HOTEL CLARE

DESIGN REVIEW BOARD PACKET
Columbia West Properties, Inc.
Ankrom Moisan Architects, Inc.

Second Recommendation Meeting
JUNE 2, 2015
DPD # 3017317

1. TOWER

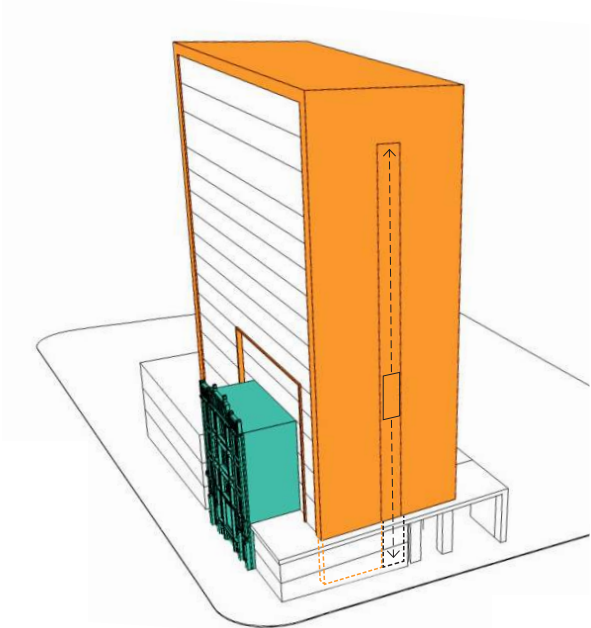
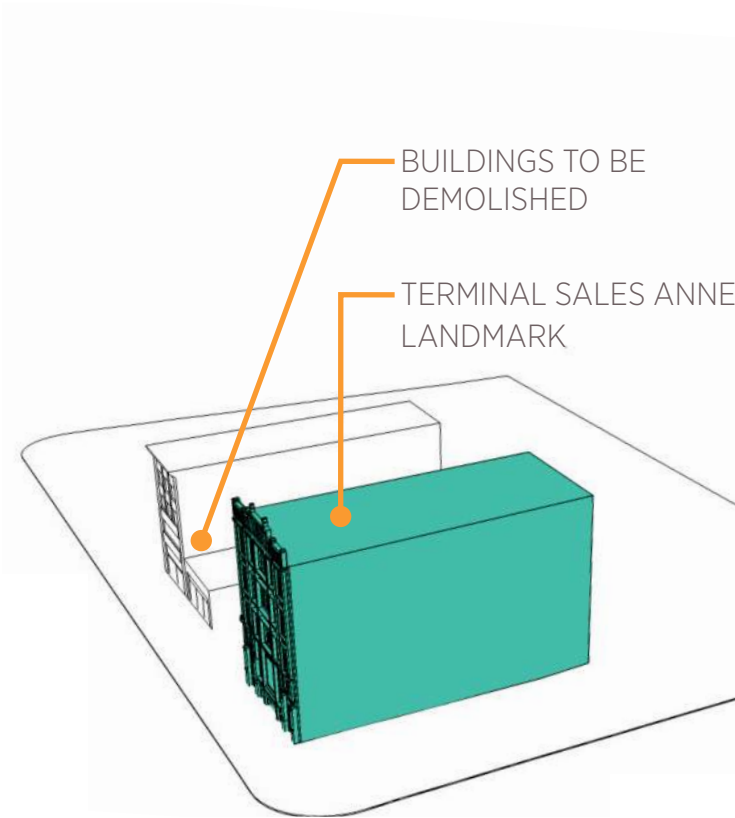
DRB Guidance:

The Board supported the smaller tower massing compared to the previously approved MUP. At the initial recommendation meeting.

The Board provided recommendations about the facade treatments, especially regarding the exterior elevator and the “patch work” design of the west elevation.

Response:

The express elevator has been relocated to be within the tower massing, rather than exterior-mounted.

The west elevation has been simplified to be one material of window wall, coinciding with the treatment of the east facade.

2. LANDMARK

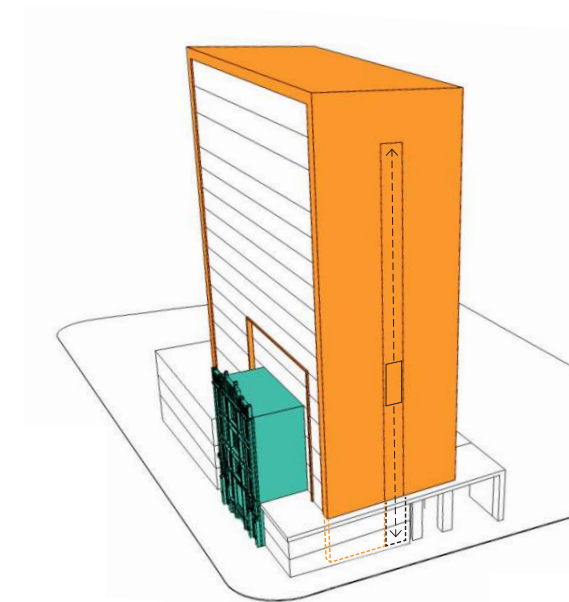
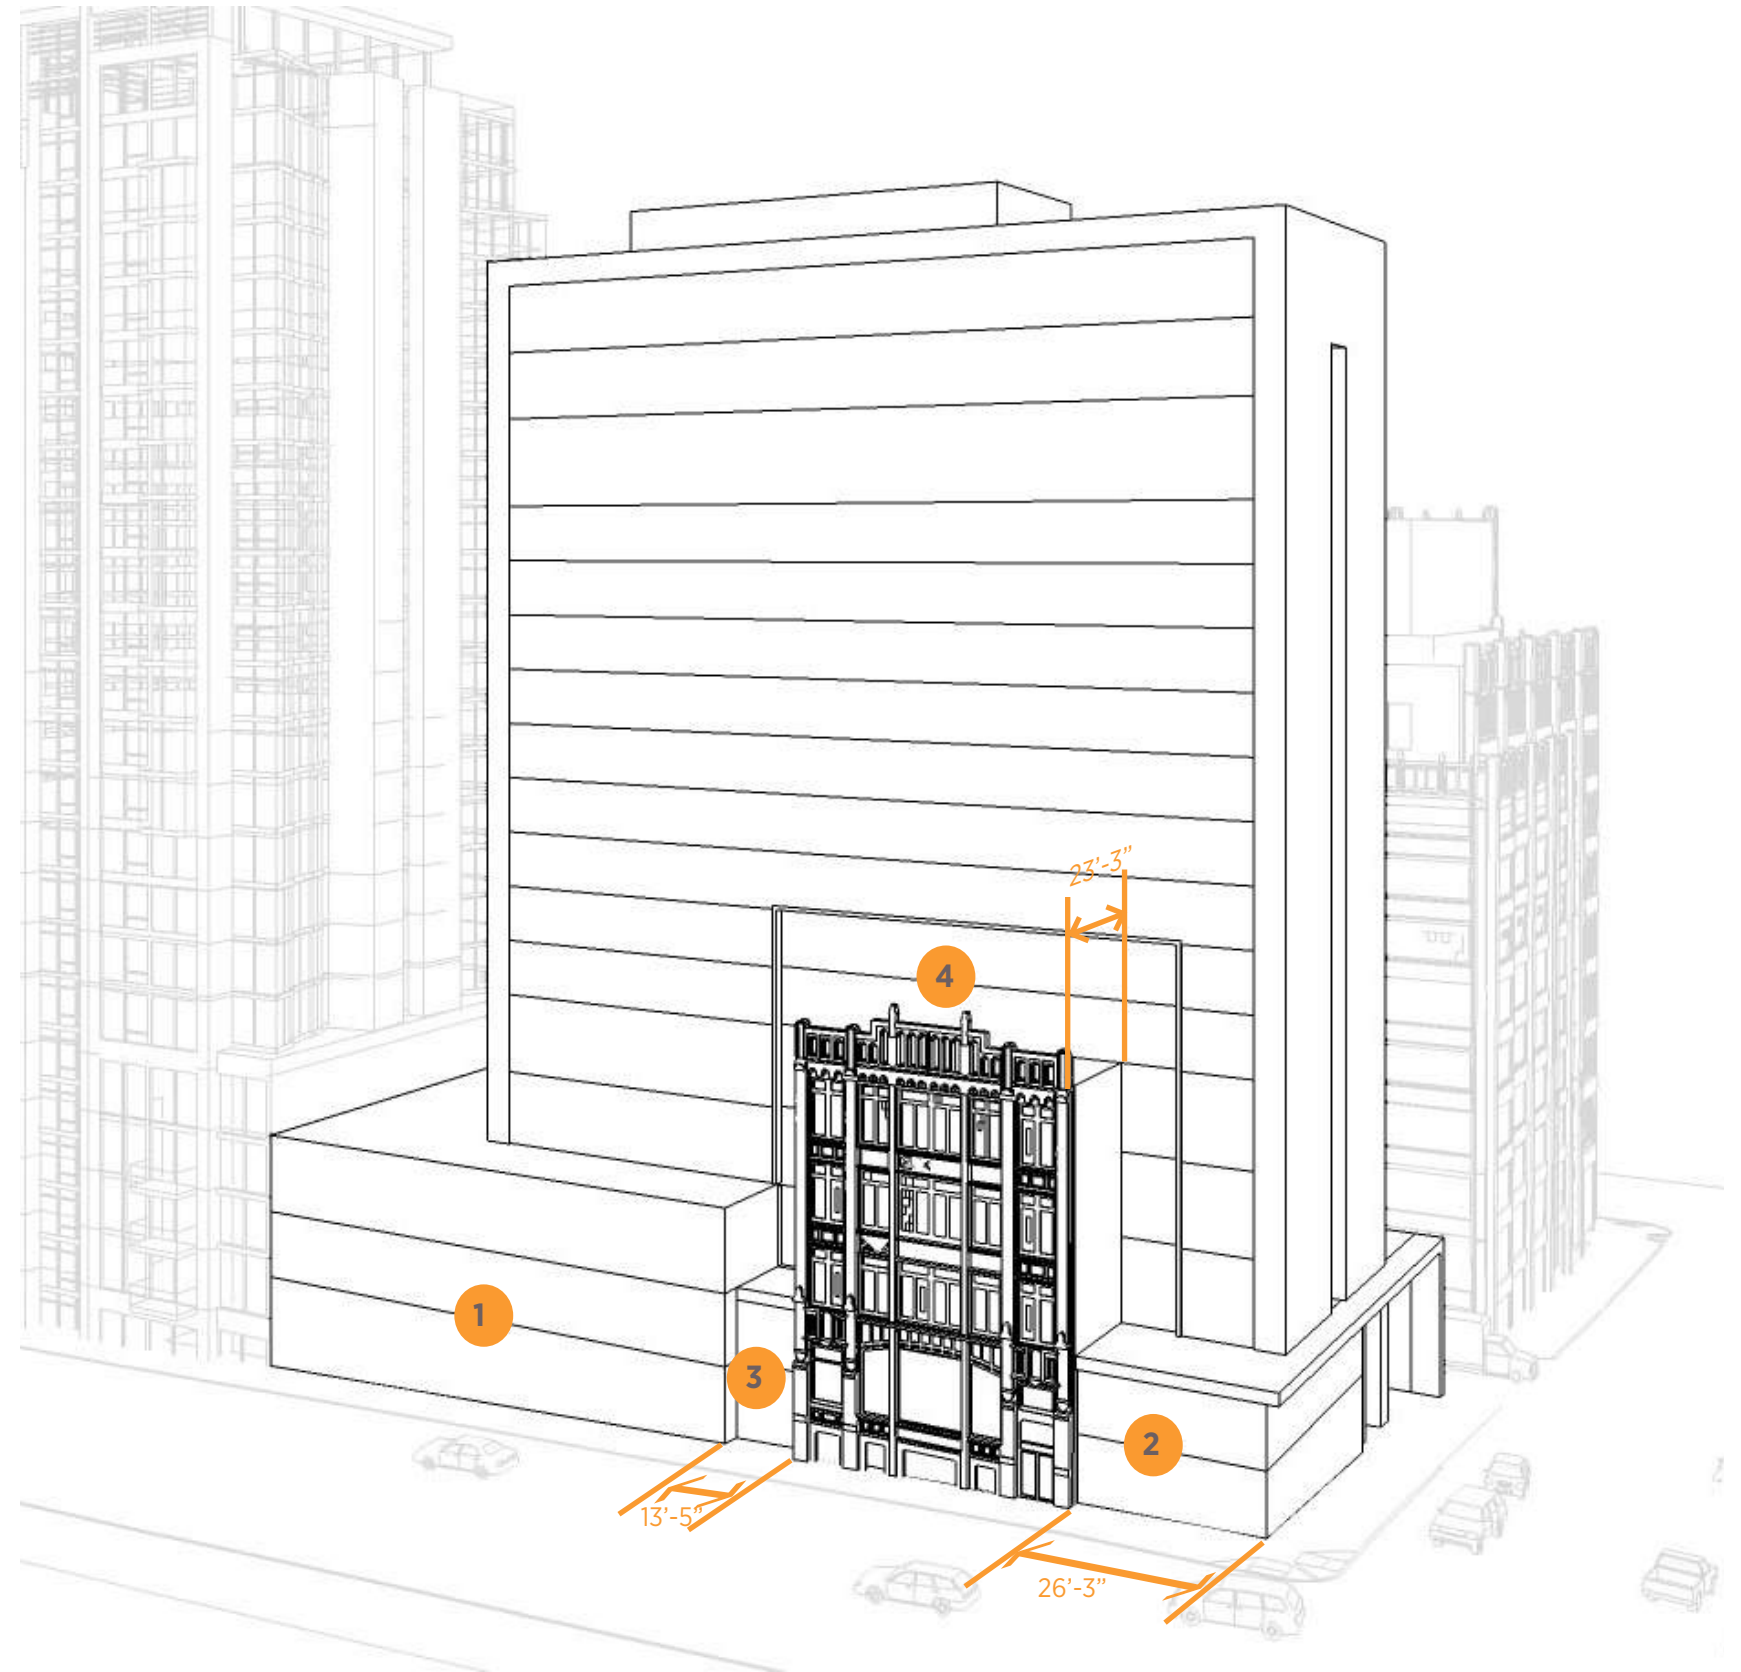
DRB Guidance:

The previous design left the north wall of the Terminal Sales Annex Building exposed, with a plaza at the street corner. There was some concern about the blank wall and plaza design, and whether there should be an entry at the corner.

Additionally, the board encouraged the creation of a special relationship at the intersections of the Landmark facade and the new construction.

Response:

The retail podium has been pulled away from the landmark giving it breathing room, the corner plaza has been replaced with an interior entry lobby that embraces the landmark, and the elevator has been made interior improving the pedestrian experience along Virginia Street.

A reveal and frame at the tower highlight the landmark as a prominent feature on the site.

3. PODIUM

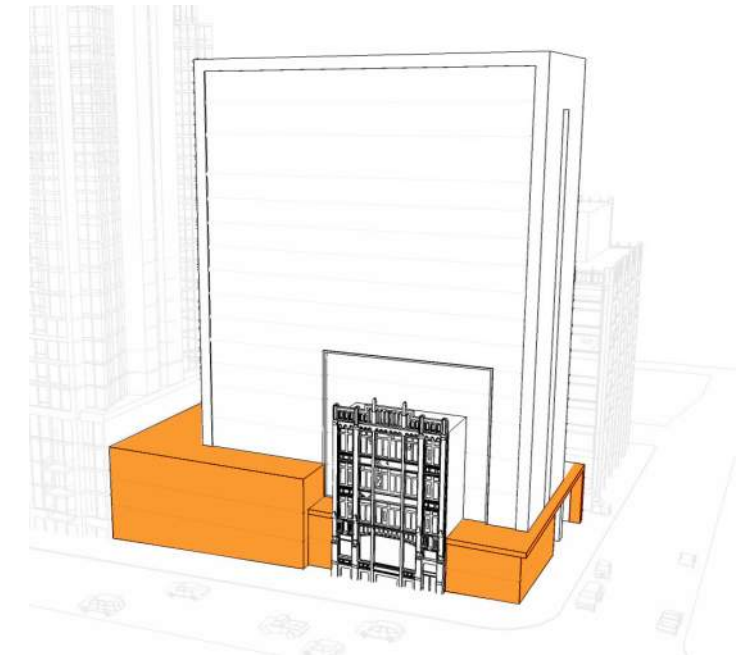
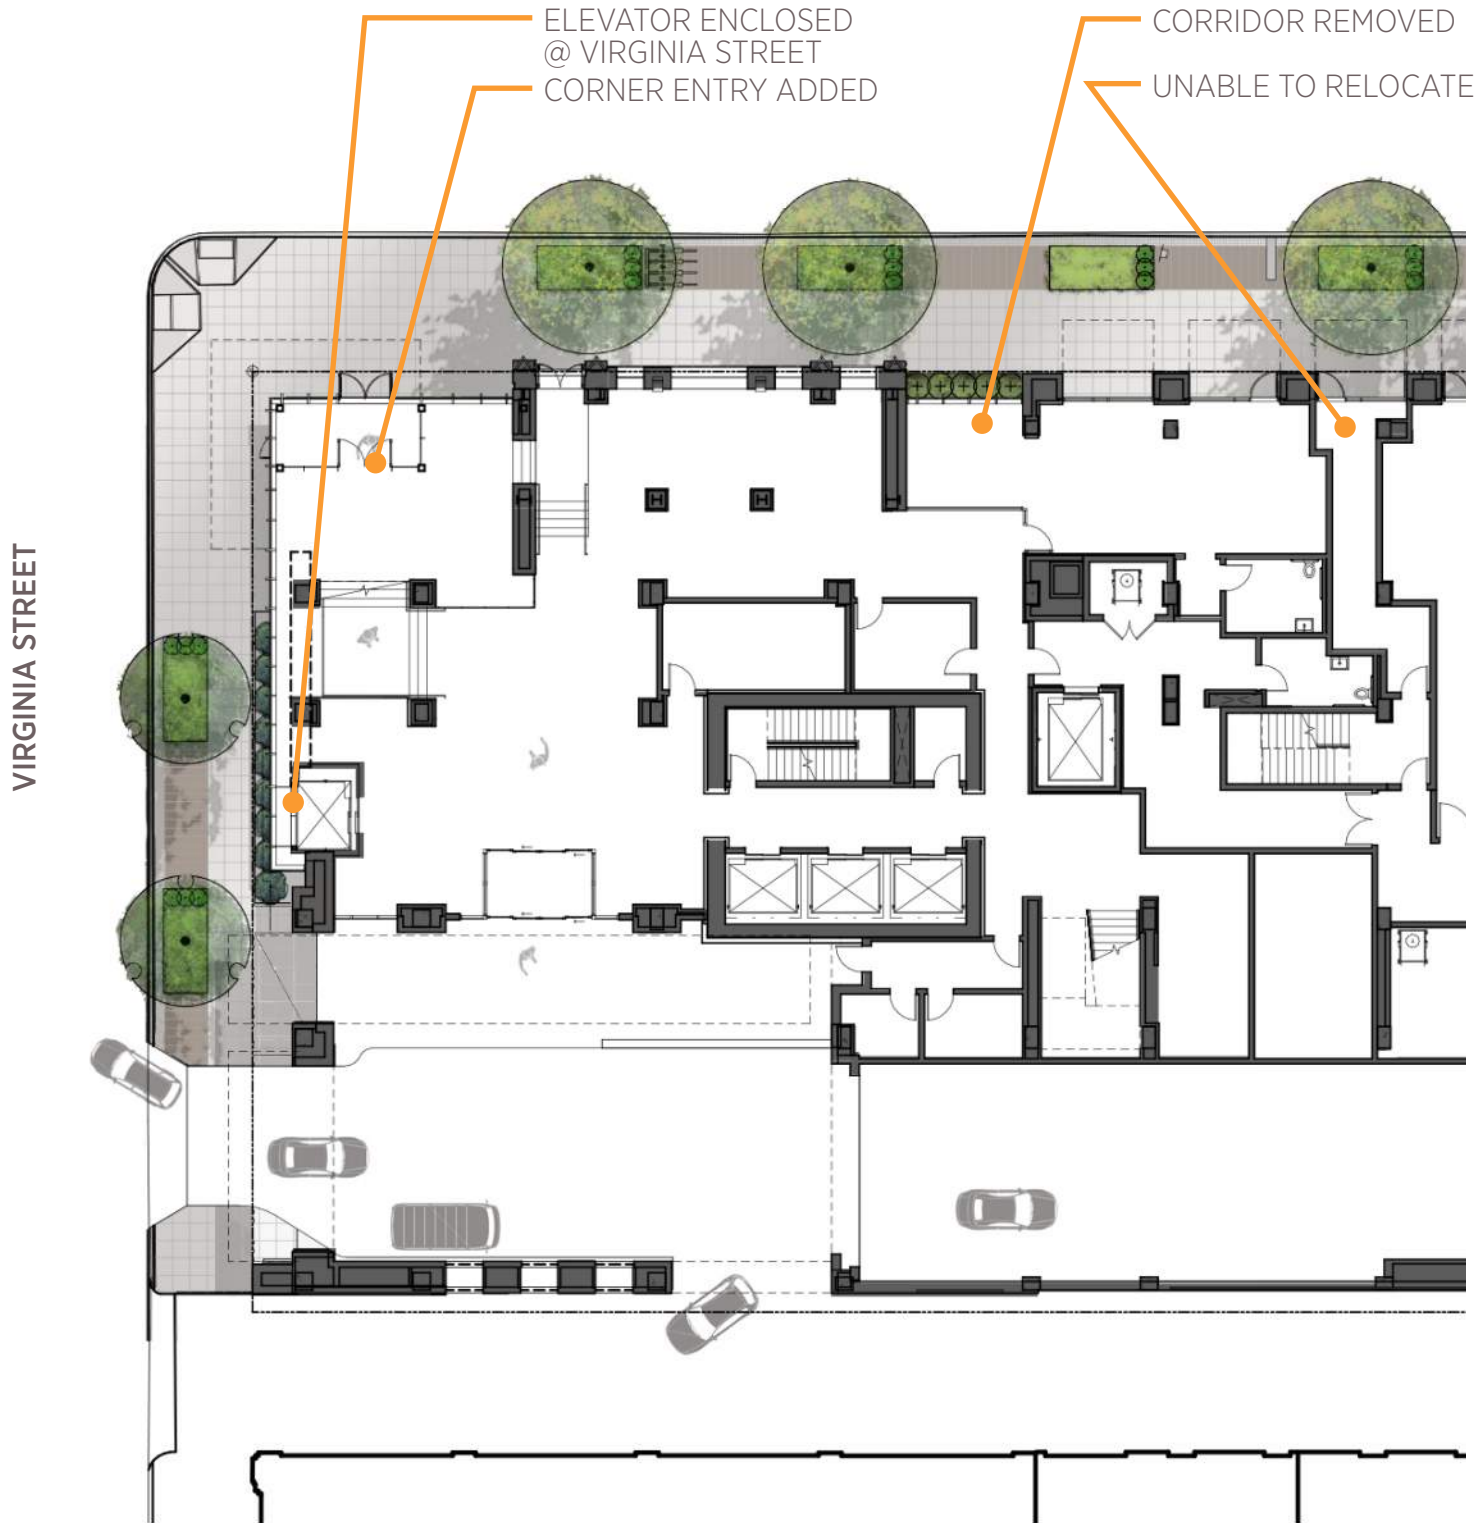
DRB Guidance:

The Board had concerns about a lack of street activation at the 2nd floor of the retail podium, and the location of the roof terrace at the rear of the building.

They asked to consider ways to increase street activation along 2nd Avenue, and that the podium should have an urban facade different from the facade at Virginia Street.

Response:

A third floor, containing guest rooms, has been added to the podium with windows that will activate the streetscape.

An entry lobby strengthens the building at the corner, and moving the elevator to the interior space improves the pedestrian experience along Virginia Street.

LEVEL 2
SECOND RECOMMENDATION MEETING

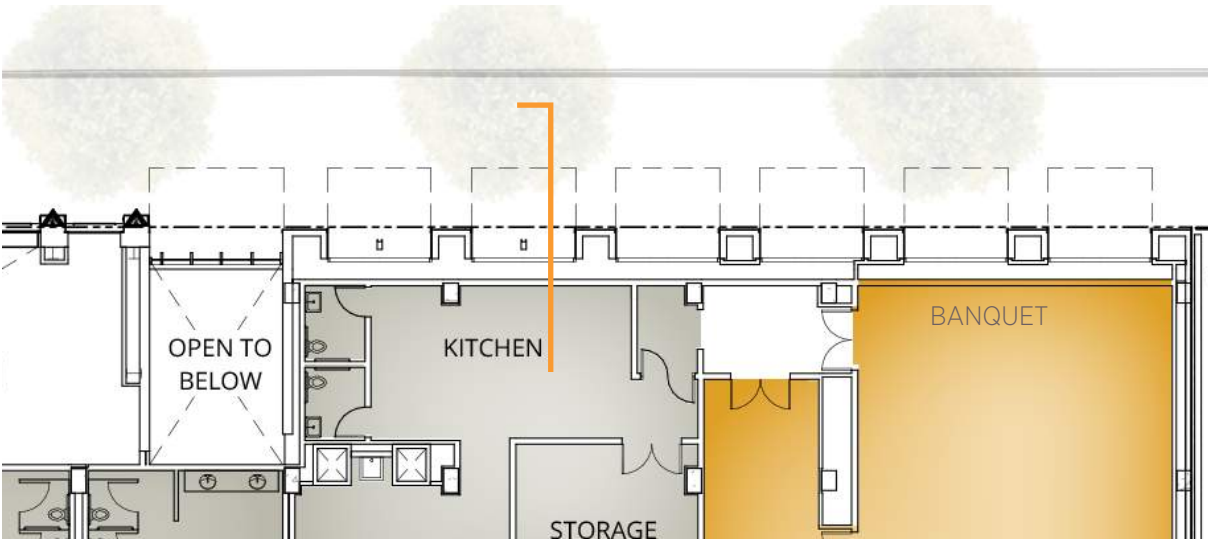
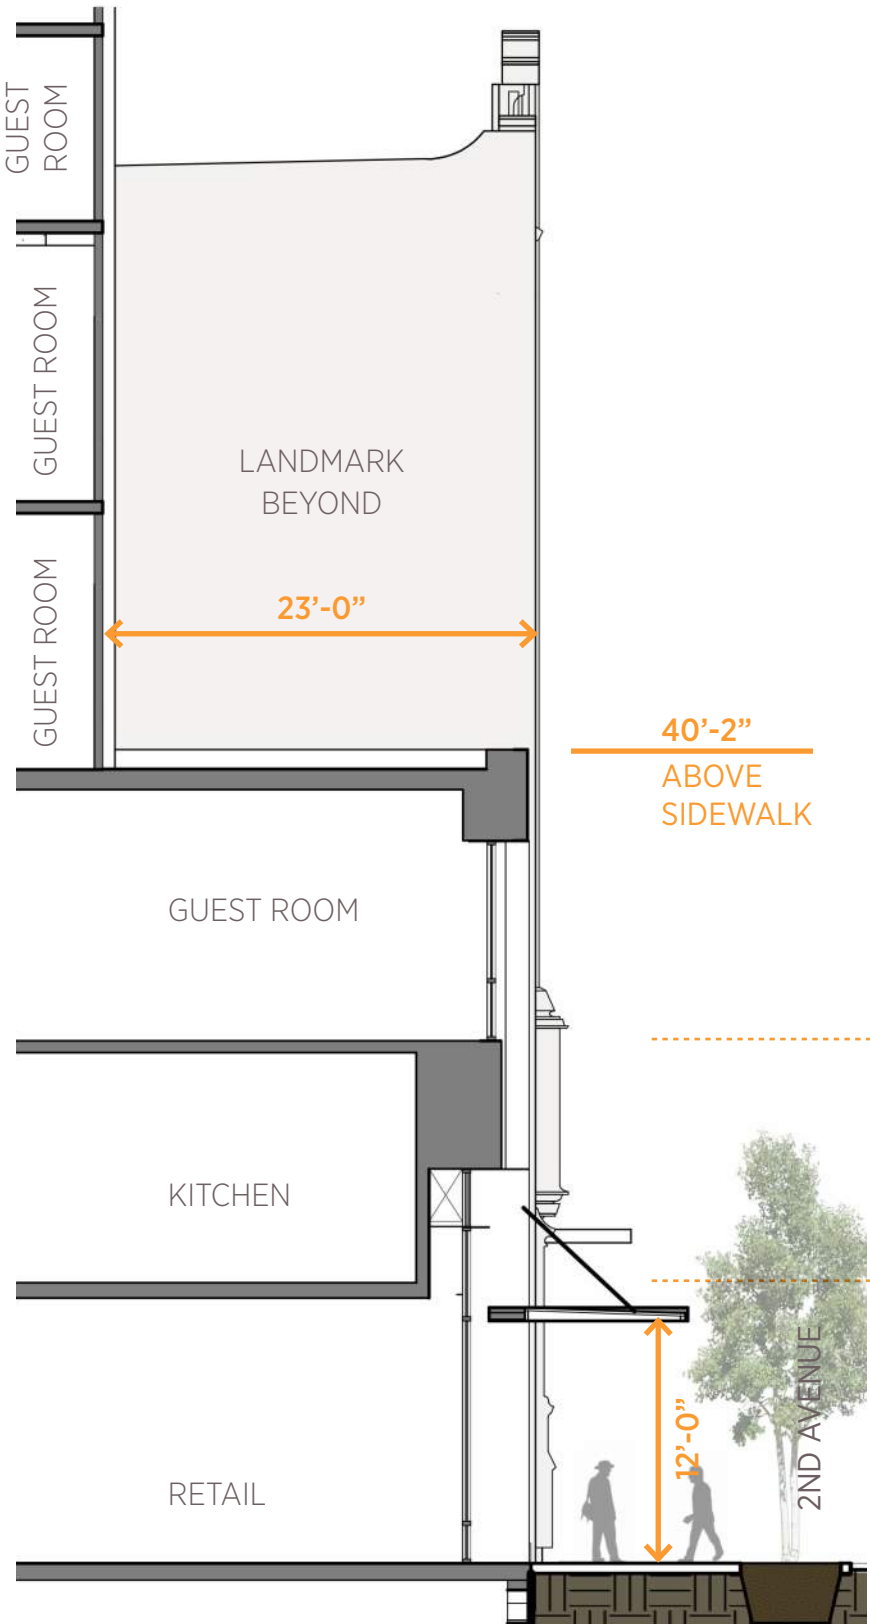
DRB Guidance:

The Board encouraged relocating the second floor kitchen uses away from 2nd Avenue.

Response:

Several new locations for the kitchen were explored. The location of chutes, elevator and stair cores, and inability to provide proper security visuals from the front desk prevented the kitchen relocation.

To address the Board’s comments, the addition of a third floor of guest rooms increases activity along 2nd Avenue, and the composition of the podium masks the second floor kitchen uses from the sidewalk.
